Office Action Summary

10/811,031

JIN ET AL.

DETAILED ACTION

FIG. 3

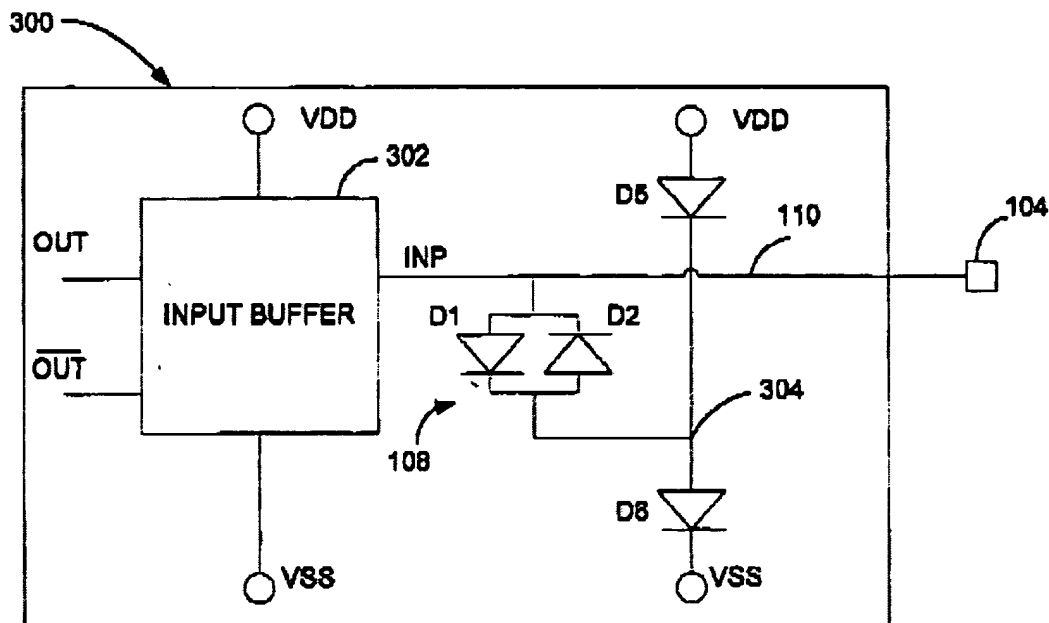
5. With regard to Claim 1, Jenkins et al., in Figure 3, discloses a low noise amplifier (300), comprising: a radio frequency input (104); and an electrostatic discharge protection circuit including (108), a pair of diodes (D1 & D2) each having a first and a second terminal; a first diode (D1) of the pair having a first terminal coupled to the radio frequency input (104) and a second terminal coupled to a first supply (VSS); and a

second diode (D2) of the pair having a second terminal coupled to the radio frequency input (104) and a first terminal coupled to the first supply (VSS); the electrostatic discharge protection circuit operable to shunt electrostatic discharge current during positive and negative electrostatic discharge events away from the radio frequency input and through the first supply (column 4 lines 35-41).

In the circuit taught by Jenkins et al., the protecting circuit is not coupled directly to the first supply (VSS), but is coupled to the first supply (VSS) via clamping diode D6.

6. With regard to Claim 9, Jenkins et al., in Figure 3, discloses a low noise amplifier (300), comprising: receiving means for receiving an RF input (104); and shunting means (108) including, a pair of diode means (D1 & D2) each having a first terminal and a second terminal; a first diode means (D1) of the pair having a first terminal coupled to the receiving means and a second terminal coupled to a first supply; and a second diode means (D2) of the pair having a second terminal coupled to the receiving means and a first terminal coupled to the first supply; the shunting means for shunting electrostatic discharge current during positive and negative electrostatic discharge events away from the receiving means and through the first supply (VSS).

7. With regard to Claim 17, Jenkins et al., in Figure 3, discloses an electrostatic discharge protection circuit (300), comprising: a pair of diodes (D1 & D2) each having a first terminal and a second terminal; a first diode (D1) of the pair having a first terminal coupled to an input/output pad and a second terminal coupled to a first supply; and a

second diode (D2) of the pair having a second terminal coupled to the input/output pad (104) and a first terminal coupled to the first supply; the electrostatic discharge protection circuit operable to shunt electrostatic discharge current during positive and negative electrostatic discharge events.

8. With regard to Claim 24, Jenkins et al., in Figure 3, discloses an electrostatic discharge protection circuit (300) for discharging electrostatic discharge events, comprising: shunting means (108) including, a pair of diode means having a first terminal and a second terminal; a first diode means (D1) of the pair having a first terminal coupled to an input/output pad (104) and a second terminal coupled to a first supply; and a second diode means (D2) of the pair having a second terminal coupled to the input/output pad and a first terminal coupled to the first supply; the shunting means for shunting electrostatic discharge current during positive and negative electrostatic discharge events.

9. With regard to Claim 31, Jenkins et al., in Figure 3, discloses a method for discharging electrostatic discharge, comprising: providing a first discharge path between an input/output pad and a first supply; providing a second discharge path between the input/output pad and the first supply; and shunting electrostatic discharge current during positive and negative electrostatic discharge events through one of the first discharge path and the second discharge path.

11. With regard to Claims 3, 11, 19, 26 & 32, Jenkins et al., in Figure 3, discloses the low noise amplifier of Claims 1, 9, 17, 24 & 31, wherein the first supply is one of a low voltage supply and a high voltage supply, and if the first supply is a low voltage, then the electrostatic discharge protection circuit is not directly coupled to a corresponding high voltage supply, if the first supply is a high voltage supply, then the electrostatic discharge protection circuit is not directly coupled to a corresponding low voltage supply.

12. With regard to Claims 4, 12, 20, 27 & 33, Jenkins et al., in Figure 3, discloses the low noise amplifier of Claims 1, 9, 17, 24 & 31, further comprising an electrostatic discharge clamp (D 5 & D6) to provide a discharge path between a high voltage supply and a low voltage supply during an electrostatic discharge event (column 4 lines 39-41 & 44-45).

FIG. 5

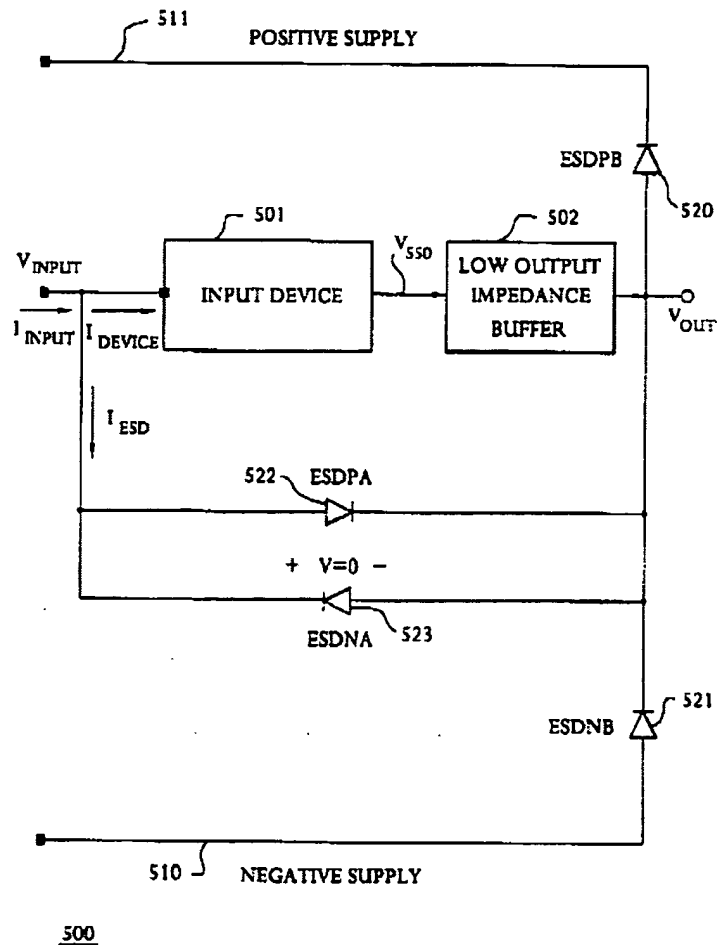
19. The prior art made of record and not relied upon is considered pertinent to applicant's disclosure. Botker et al. (US 5,764,464) in Figure 5, teaches an ESD protection circuit for a low input bias current circuit wherein a radio frequency input node (V_{INPUT}) is coupled to voltage supply through shunting diodes 522 & 523, which are coupled anti-parallel to each other. A clamping circuit maintains a voltage level between the positive and negative supply. Botker et al. teaches that positive ESD events are shunted to the positive supply through diodes 522 and 520. Negative ESD

events are shunted to the negative power supply through diodes 521 and 523 (column 4 lines 20-26).
